FINAL PLAT

PINE MEADOW ADDITION

RE: SUB 2001-61 -- Final Plat of Pine Meadow Addition

STAFF REPORT

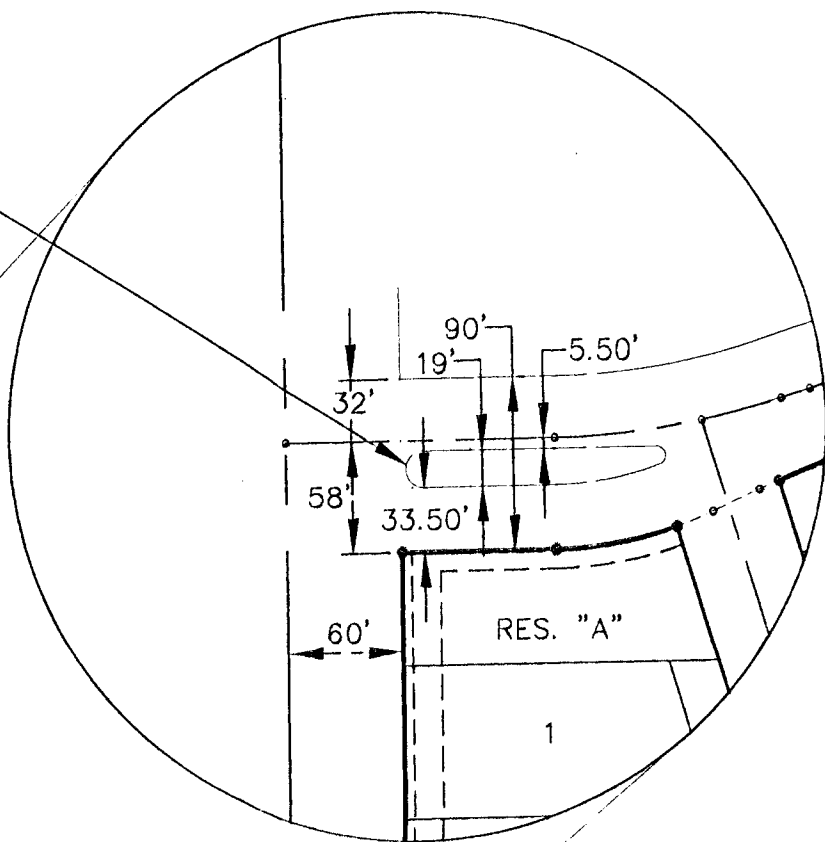
- G. Complete access control shall be dedicated along Greenwich Road and denoted on the face of the plat.
- H. The Applicant shall guarantee the paving of the proposed streets.

- O. Approval of this plat will require a waiver of the lot depth to width ratio for Lot 18, Block 1 of the Subdivision Regulations. The Subdivision Regulations state that the maximum depth of all residential lots shall not exceed 2.5 times the width. A modification has been approved.

- P. The City Fire Department/GIS needs to comment on the plat's street names. Pine Meadow should be replaced with Killenwood. Gatewood needs to be replaced with Hartmoor or Donegal. Gatewood Court needs to be replaced with Crest Ct (southwest corner) and by Bristol Ct (Southeast corner).

Donegal Lane needs to be revised to Donegal.
- Q. The wall easement needs to be referenced in the plat's text.
- R. A bearing needs to be added along the north line of Lot 19, Block 1.
- S. The centerline of Killenwood needs to be located along Greenwich Road.
- T. A right-of-way width needs to be added for the west end of Killenwood.
- U. The legal description needs to be corrected to remove lines that are repeated.

The street names have been revised as requested.

- EE. The representatives from the utility companies should be prepared to comment on the need for any additional utility easements to be platted on this property. ***KGE has requested additional easements, which have been denoted on the final plat.***
